**Ballymun / Finglas
to City Centre Core
Bus Corridor
Scheme**

**NTA Observations on
the Proposed
Scheme Submissions**

February 2023

Figure 2-2-19: Extract from General Arrangement Map Sheet 11

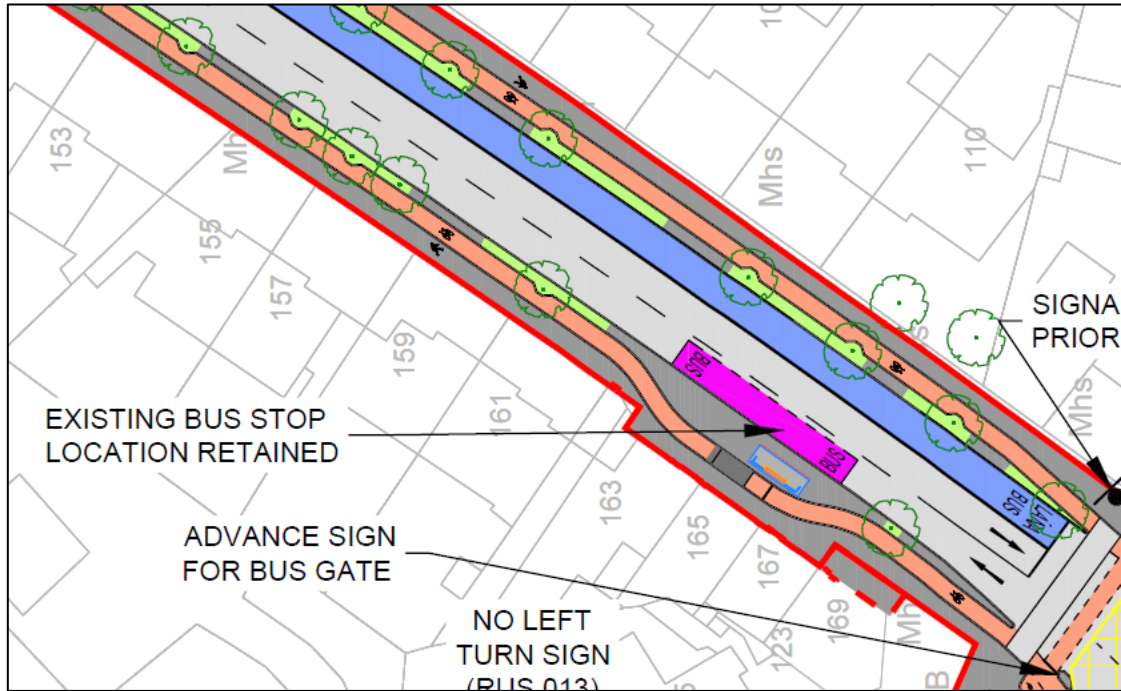
There is an existing bus stop in front of the row of shops at No.163a to 168 St. Mobhi Road (on the western side at the southern end at the junction with Botanic Road as shown in Figure 2-2-19 an extract of the EIAR Volume 3 Chapter 4 Proposed Scheme Description Appendix the General Arrangement drawing Sheet 11. An aerial view of this location is shown in Figure 2-2-20 and street views in Figures 2-2-21 and 22.

There is a 1.5m wide layby provided for buses to pull in partially off the road as shown in Figure 2-2-22. The existing bus stop shelter sits on a 3m wide concrete apron and behind that the private landing area in front of the shops is 2.7m wide, giving a total width of 7.2m from the road edge to the front of the building.

In the Proposed Scheme, the bus layby will be removed, and the 3m wide bus stop island and shelter will move forward by 1.5m closer to the road. A cycle track will be provided behind the bus shelter in accordance with the standard detail included in the *Preliminary Design Guidance Booklet for BusConnects* (included in EIAR Volume 4, Appendix A4.1) as shown in Figure 2-2-23.

Figure 2-10-4: Extract from General Arrangement Sheet 27

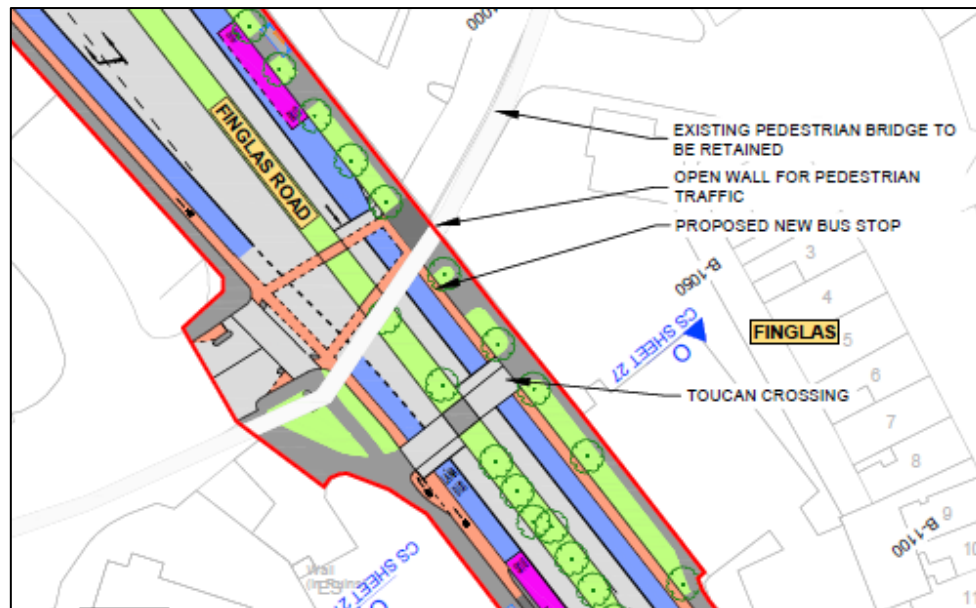
Sheet 27 of the '02. General Arrangement' drawings in Volume 3 of the EIAR, for Finglas Road at Church Street, differs from Image 4.10 in Chapter 4 (Proposed Scheme Description) in Volume 2 of the EIAR that shows the proposed public realm at the junction of Finglas Road and Church Street.

There is a minor discrepancy between Sheet 27 of the '02. General Arrangement' drawings in Volume 3 of the EIAR and Chapter 4 (Proposed Scheme Description) in Volume 2 of the EIAR that shows the proposed public realm at the junction of Finglas Road and Church Street. The Proposed Scheme is

shown in full on the General Arrangement drawing, which differs from the public realm image in that it includes cycle lanes connecting across Finglas Road from the western side to Finglas Village on the eastern side, with traffic signal control across the Finglas Road dual carriageway. To accommodate the additional at-grade cycle crossings the proposed bus stop was moved a little further north. These additional details are not shown on the image for the public realm in this vicinity beside the historic St. Canice's Church.

Figure 2-11-14: Extract from General Arrangement Drawing Sheet 13

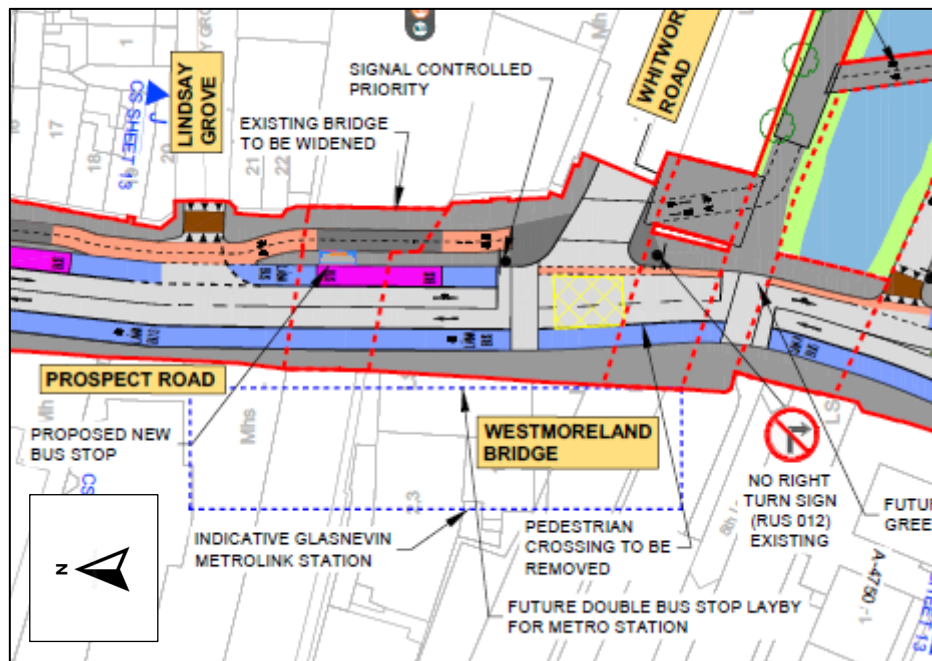
This issue refers to Sheet 13 of the General Arrangement Drawings:

Provision of a bus stop at the future railway/metro station is annotated on the proposed scheme drawing shown in Figure 2-11-14. The detailed arrangement of the station and the surrounding plaza is included in the Metrolink scheme in a separate planning application, and this proposal was developed in coordination between the BusConnects and Metrolink design teams.

Figure 2-11-15: Extract from General Arrangement Drawing Sheet 17

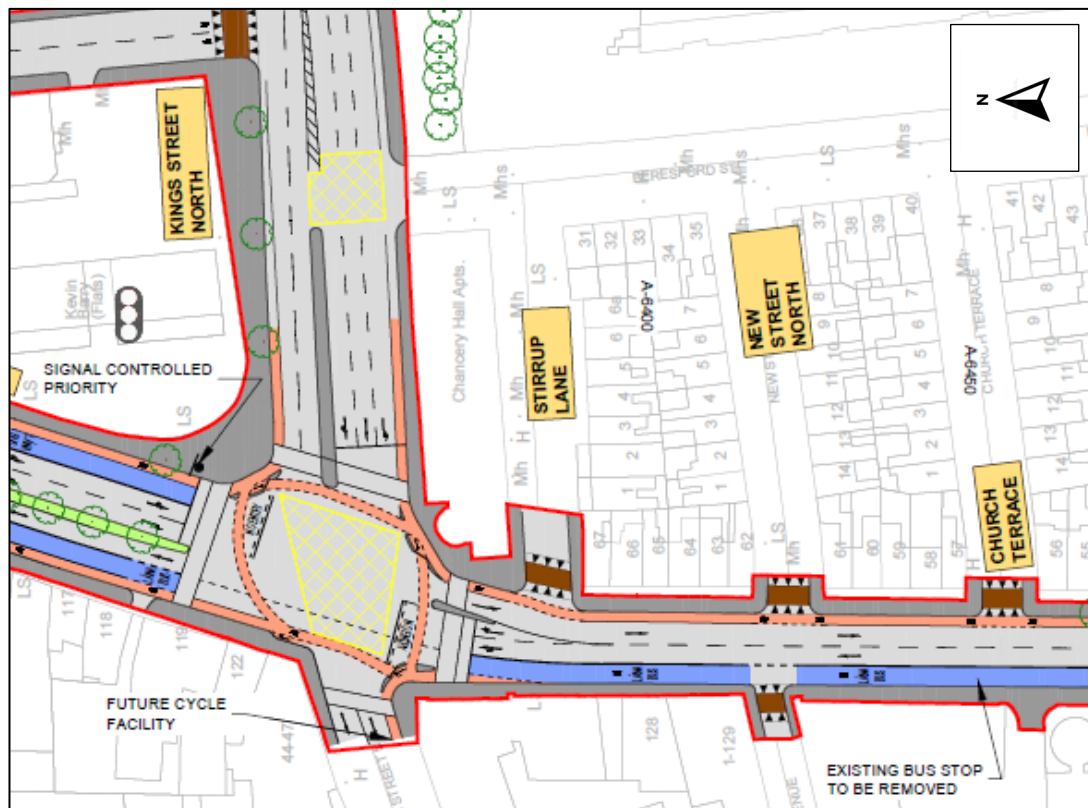
This issue refers to Sheet 17 of the General Arrangement Drawings:

The Proposed Scheme layout retains a short right-turn lane on Church Street northbound at the junction with North King Street, which is similar to the existing provision as shown in the aerial photograph in Figure 2-11-16. There is a small demand for this right-turn, as most traffic headed in the direction of Bolton Street tends to use the parallel route to the east along Beresford Street from which there are more opportunities to turn right. In this regard there will be no material change in the traffic layout and no increase in risk of queuing that could affect the LUAS crossing at Chancery Street over 300m further south.

Figure 2-11-30: Extract from Typical Cross Section Sheet 5 at St. Mobhi Road

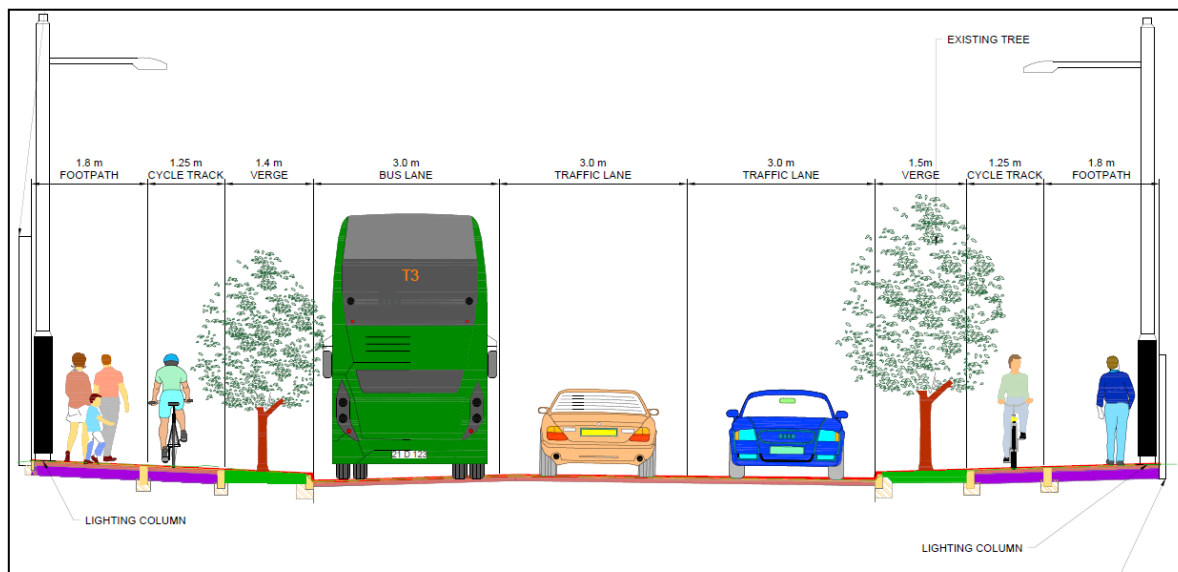
- a) *“The cycle track is shown between the grass verge and footway. A Section drawing for Sheet 8 does not appear to be included in submission (Section EE is on Sheet 9). It is not clear therefore if a grade separation between the cycle track and footpath is still proposed. As per general comment above, consideration should be given to routing the cycle track outside the verge.*

The typical proposed cross section on St. Mobhi Road is shown in Figure 2-11-30 extracted EIAR Volume 1, Part 3, Section 04, Typical Cross Sections Sheet 5.
